# T ECHNICAL INFORMATION

90953

**Subject** ▶ Change of brand logo position

**For Models** ▶ AT-3623, AT-3630, BBC231U, BBC300L

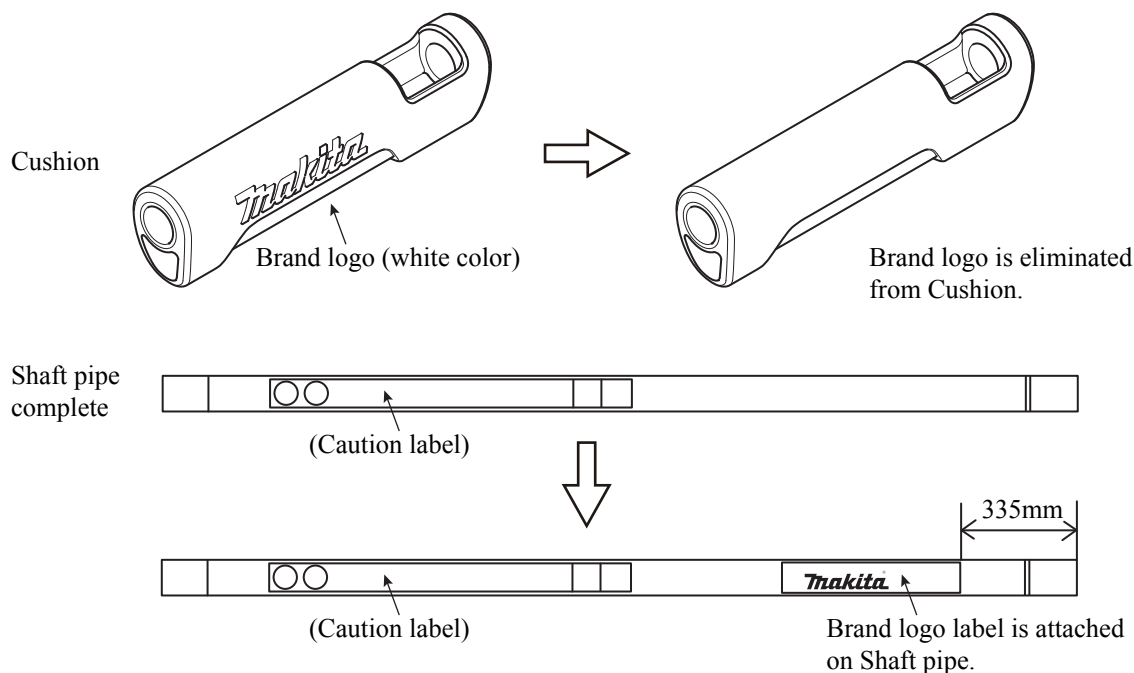
**Description** ▶ Brand logo position has been changed to Shaft pipe from Cushion as drawn below.
